**STATE OF MAINE**  
**DEPARTMENT OF HEALTH AND WELFARE**  
AUGUSTA, MAINE 04330

October 6, 1975

Subject: Lot #1 (revised) Greeley Acres Subdivision, Leavitt Road, Augusta

MAINE DEPARTMENT OF HEALTH AND WELFARE APPLICATION FOR PRIVATE SEWAGE DISPOSAL PERMIT (For systems disposing of less than 2000 gallons per day) This is NOT a permit; this form when completed must be presented to the Local Plumbing Inspector to obtain a permit. Page 1 of 2

Private Sewage Disposal Plan

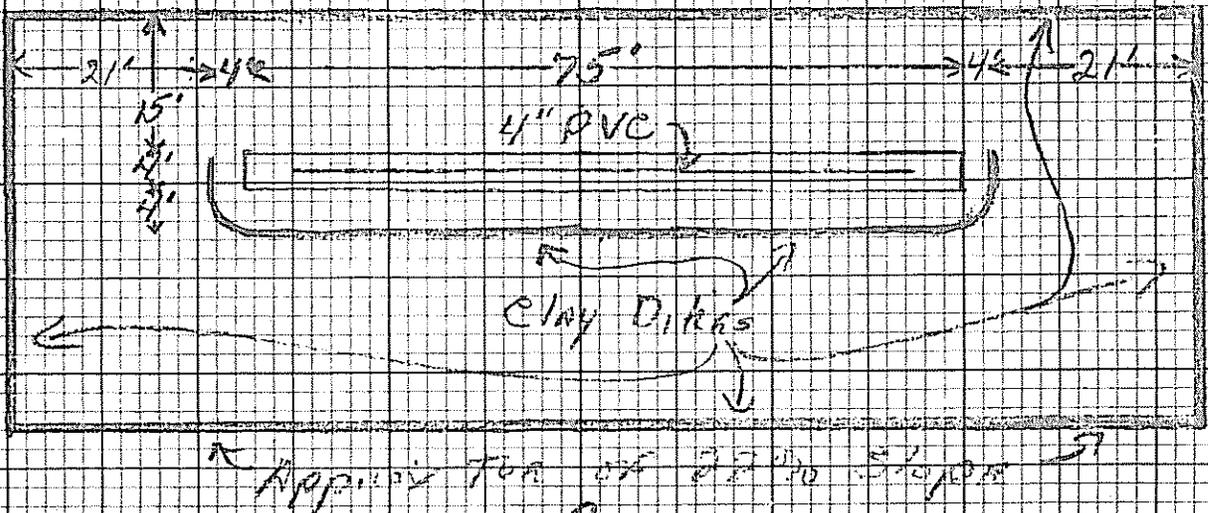
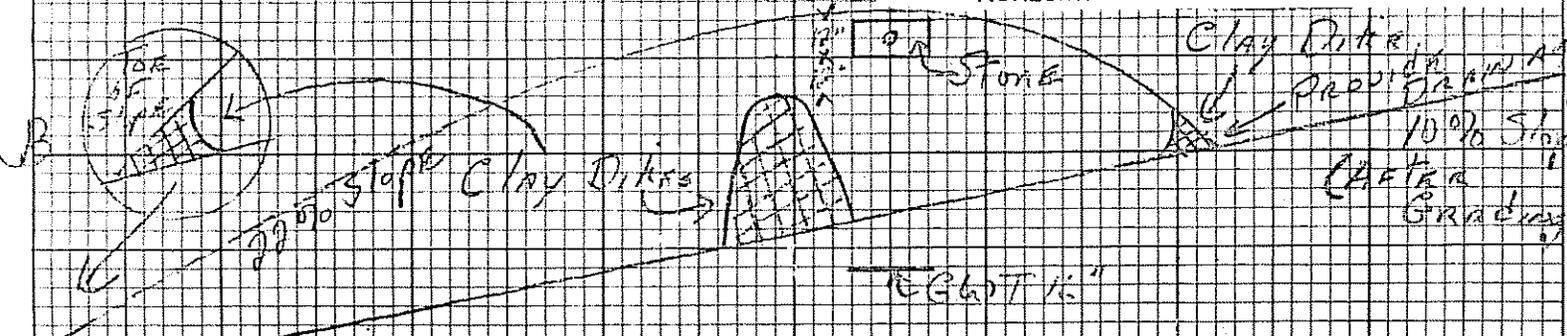
Several days ago your Mr. Lambert visited Mr. Toppan of this office, and said that due to a surveying error the house foundation had been installed where the mound was supposed to go. He wanted to know if a 20' X 70' bed could be installed behind the house location in as much as the foundation had been installed. Mr. Toppan said that a new HHE-200 form would have to be drawn up prior to any further consideration.

On October 2, 1975, Mr. Richard Baker, L.P.I., brought in a modified HHE-200 form. However, the soils in the new area were not indicated and Mr. Toppan decided to visit the site. Therefore on October 3, 1975, Messrs. Toppan and Martin both from this office, inspected the premises. They were very surprised to find a house completely framed and sided. The soils in front of the house were as Mr. Rideout reported for the mound. However, where Mr. Lambert wanted to put the bed system was quite unsuitable. There was six inches of silt loam over a very firm silt clay, with severe mottling at six inches. It is this office's opinion that the water table is extremely close or on to the surface in the spring and for possibly other periods during the year.

In consideration of the undesirable site conditions found, and the likelihood of a sewage disposal system not functioning properly, we hereby deny any request to install a mound disposal system as proposed. Perhaps the only alternative would be to install a mound for the dwelling on the front of lot #3, and combine lots #2 and #3 with #1.
